V2500-A1 SERIES PROPULSION SYSTEMS SERVICE BULLETIN

This document transmits Revision 2 to Service Bulletin EV2500-73-0103 and Revision 2 to the Supplement

V2500-ENG-73-0103

ENGINE FUEL AND CONTROL – FUEL SYSTEM TUBES – INTRODUCTION OF REVISED CLIPPING FOR
THE HP SERVO EXTERNAL FUEL TUBE ASSEMBLY

General View
Figure 1

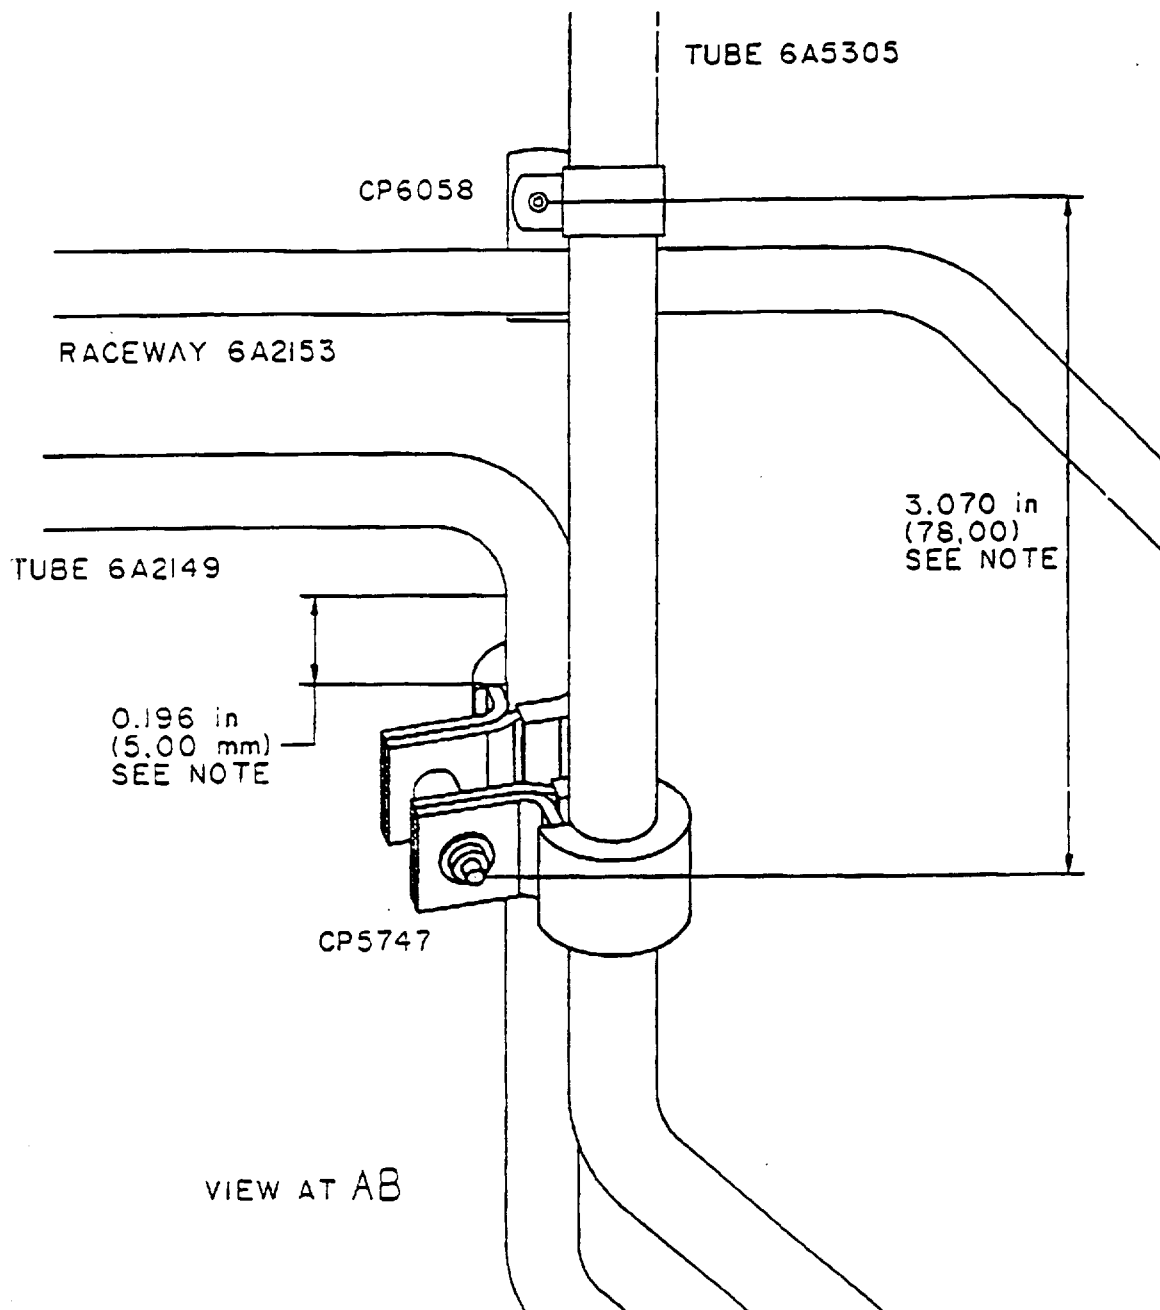
(1) In order to provide improved gripping characteristics, Adel 400WSS range of clips have been replaced with AS62400 range of clips at the following points:

CP 5701, 5747 and 6058

(2) The quantity of washers at clip point 6058 has been reduced from 2 off to 1 off.

(3) The opportunity has been taken to optimise the attaching bolt length at clip point 5701.
